**PCN# 20120817000  
Die and Data Sheet Revision for DAC8562 Devices  
Change Notification / Sample Request**

**Date:** 8/24/2012  
**To:** MOUSER PCN

**20120817000**

Sample product shipping label to indicate die rev location (**not actual product label**)

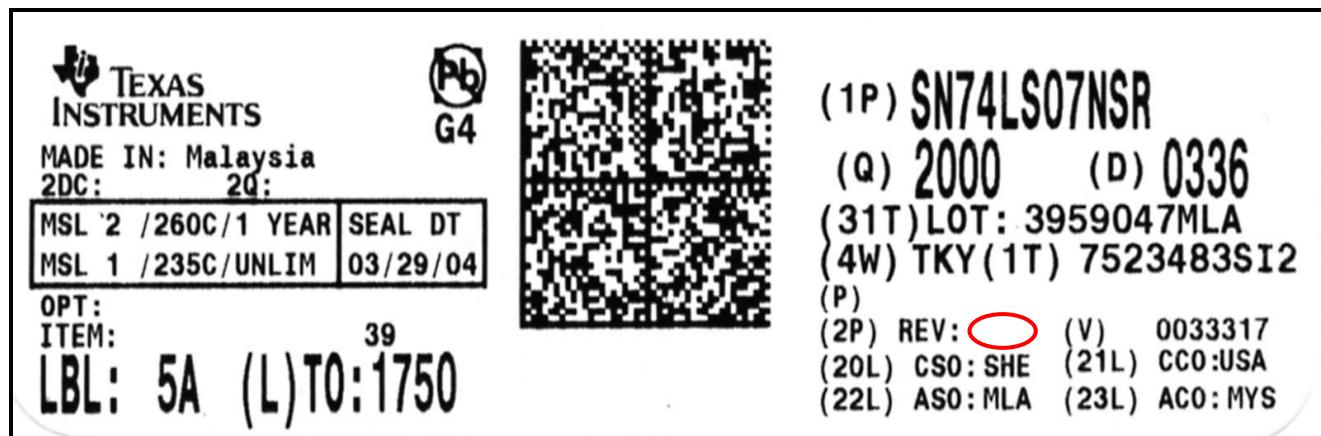
**Die Rev designator will change as shown in table & sample label below:**

Current	New
Die Rev [2P]	Die Rev [2P]
B	C
